TECHNICAL EVALUATION & PRELIMINARY DETERMINATION

Fernandina Beach Dissolving Sulfite Pulp Plant
Facility ID No. 0890004

Project No. 0890004-070-AC
Application for Minor Air Construction Permit
New Bioethanol Production Process

March 13, 2024

Figure 4. Simplified Diagram of the Bioethanol Production Using SSL as feedstock.

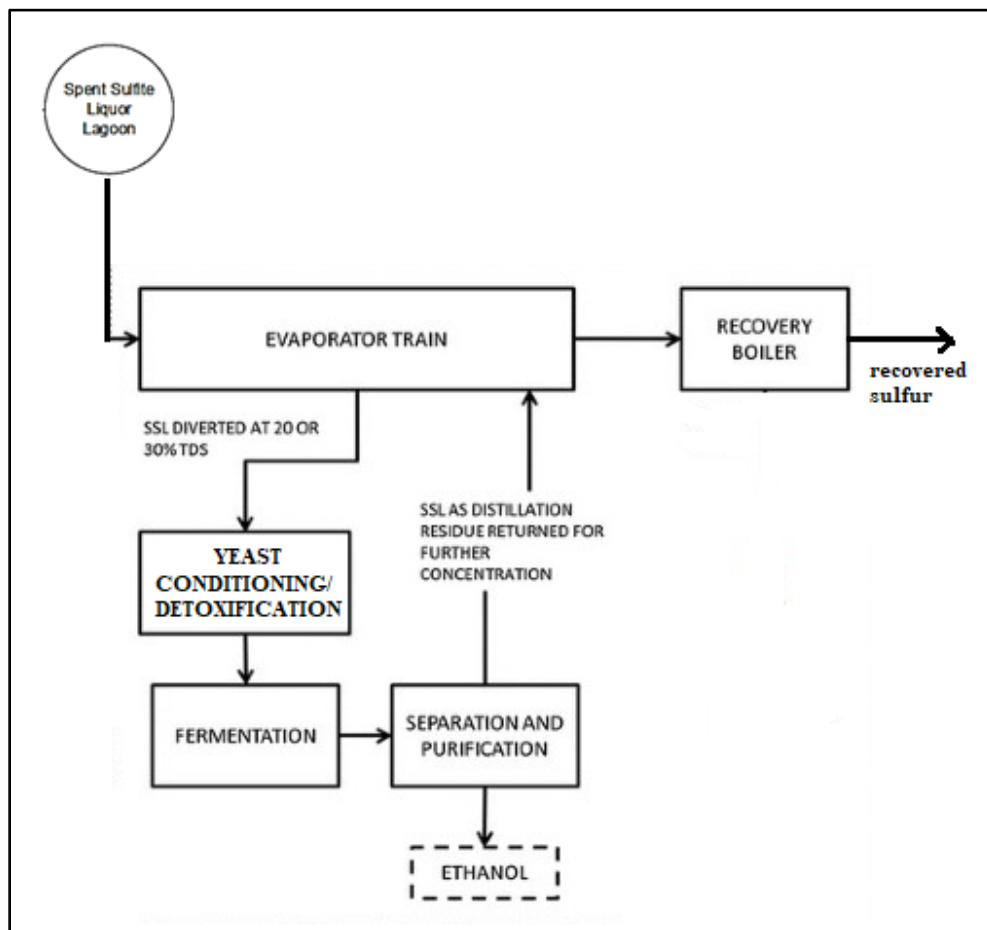
SSL Evaporation. The evaporator system at the plant reduces the water content of the SSL, before it's fired in the Sulfite Recovery Boiler (EU 006). For ethanol production, the SSL will be taken from the optimum stage of the evaporator system, where it is concentrated to approximately 20-30% total solids with the vast majority of methanol already separated from the liquor. The SSL will be returned to the next stage of the evaporator after the fermentation process. Prior to fermentation, the SSL will be neutralized with ammonia in the existing pulp mill to reach the optimum pH for yeast cells to ferment.

Yeast Conditioning. Yeast will be conditioned and acclimated to the fermentation process in the yeast conditioning tank. Weak caustic solution will be used to kill bacteria and weak yeast cells without harming the healthy yeast cells.

Fermentation. During fermentation, sugars contained in the concentrated SSL (predominantly hexoses such as glucose) are transformed to ethyl alcohol, carbon dioxide (CO₂) and various secondary products such as other alcohols, aldehydes, etc. Fermentation will be on a continuous basis with an expected 48-hour cycle. There will be a total of three fermenters, each having controlled temperature and controlled additions of yeast to maintain optimum fermentation conditions. Used yeast will be recycled and may be made up with fresh yeast and nutrients. The product of fermentation, fermentation broth called "beer," is a weak ethanol solution and contains

Distillation and Dehydration (D&D). From the beer well, the beer will be sent to the D&D process which will include the degassing column, the distillation column ("beer" column), the rectification column, and dehydration. The alcohol stream will be concentrated in the rectifier column. Non-ethanol fermentation products (such as yeast, bacteria, non-fermentable solids, mineral salts) are removed from the lower section of the rectifier column and sent to the clean-in-place (CIP) system for further treatment. Hydrated alcohol from the distillation process undergoes dehydration to produce ethanol at approximately 99.67% by weight purity. The process is performed in a continuous operation where the hydrated alcohol is superheated by steam in a shell and tube heat exchanger to ensure that the ethanol stream is always in the vapor phase as it passes through molecular sieve beds. The ethanol product from the dehydration unit will be processed through one of two shift tanks, with on-specification ethanol being routed to the ethanol storage tank and off-specification ethanol being routed to the off-spec ethanol tank and back to rectifier column. The on-spec ethanol from storage tanks will be loaded to trucks or rail for shipping.

Air Pollution Control Equipment. VOC emissions from the yeast conditioning tank, continuous fermenters, beer well, degassing column, beer column and dehydrator will be controlled by a vent scrubber. The vent scrubber will use cold water as the primary scrubbing solution to condense ethanol vapor. The liquor at the bottom of the scrubber that contains recovered ethanol from the scrubber will be sent back to the beer well by the vent scrubber pump. The design removal efficiency of the scrubber is approximately 96%. The ethanol vapor that could potentially be generated in the shift process tanks, off-spec process tanks, and product storage tank will be eliminated by the internal floating roof of these tanks that leaves no space between the floating roof and liquid ethanol for the formation of ethanol vapor.

Figure 6. Process Flow Diagram of the Existing Evaporator Vents Methanol Condenser System (EU 021).

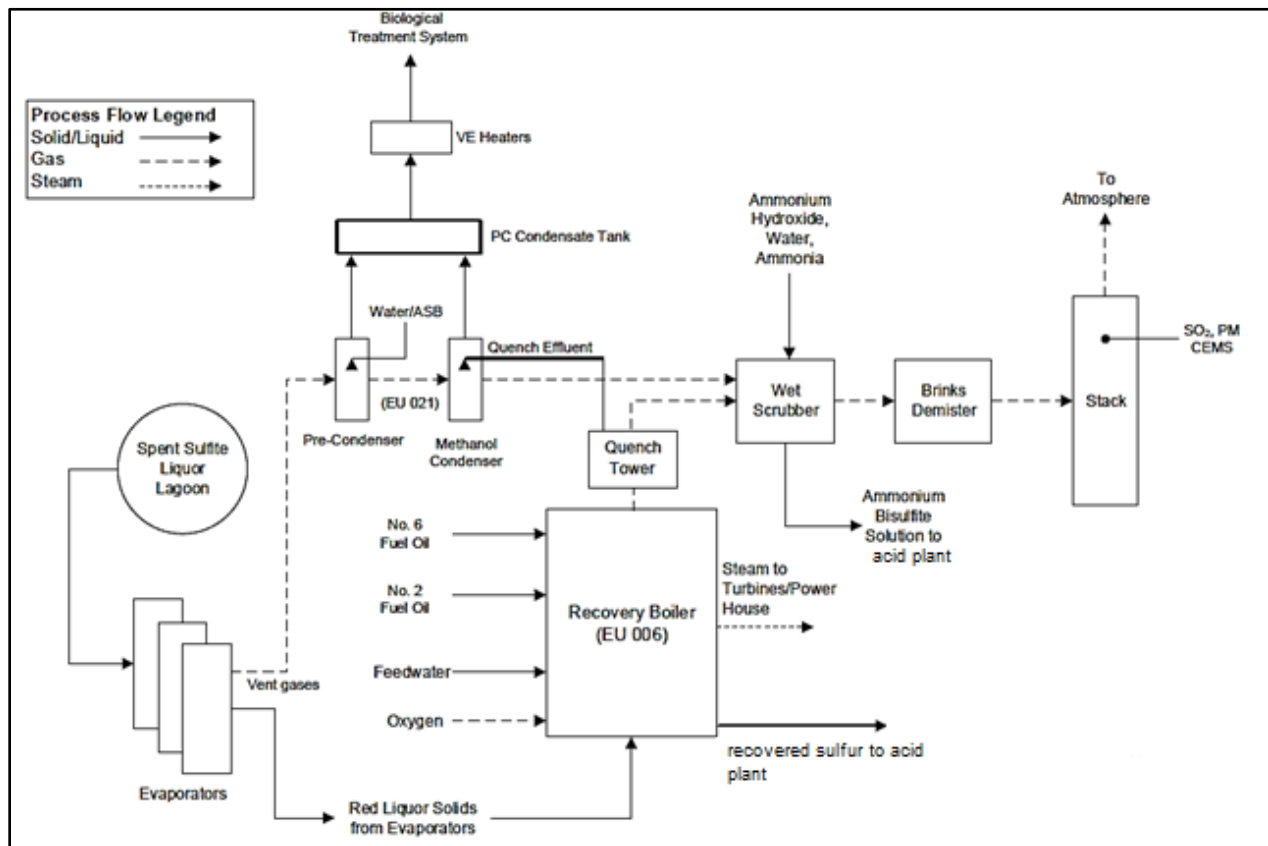
The Evaporator Vents Methanol Condenser System is an environmental system that condenses methanol vapor from the evaporator non-condensable gas (NCG) streams. Two sets of multiple effect evaporators (Line A and Line B) are used to increase the solids concentration of SSL. Steam is used to eject the evaporator vent gases through the system. These gases are piped to a pre-condenser which condenses the steam, followed by the main methanol condenser to condense methanol. The NCG gases are then sent to the multistage wet scrubber/Brinks demister at the Recovery Boiler (EU 006) before being vented to the atmosphere.

A third multiple effect evaporator train (Line C), consisting of three refurbished existing evaporator bodies, is used to increase the solids concentration of weak Hot Caustic Extract (HCE). The third MEE train is also vented to the pre-condenser followed by the main condenser, and then to the Recovery Boiler wet scrubber.

The process flow diagram of EU 021 along with the affected by this project Sulfite Recovery Boiler (EU 006) units is shown below in **Figure 6** (next page) for informational purposes.

The Bioethanol Production Project is not expected to affect EU 021 emissions and the RPF Plant's compliance with 40 CFR Part 63, Subpart S. Methanol is incompatible with yeast, so the SSL must be sent to fermentation process from the optimum stage of the Evaporator System such that the methanol is already mostly separated from the liquor. In addition, the proposed heat recovery projects will not impact the way methanol is collected and treated in the wastewater treatment system.
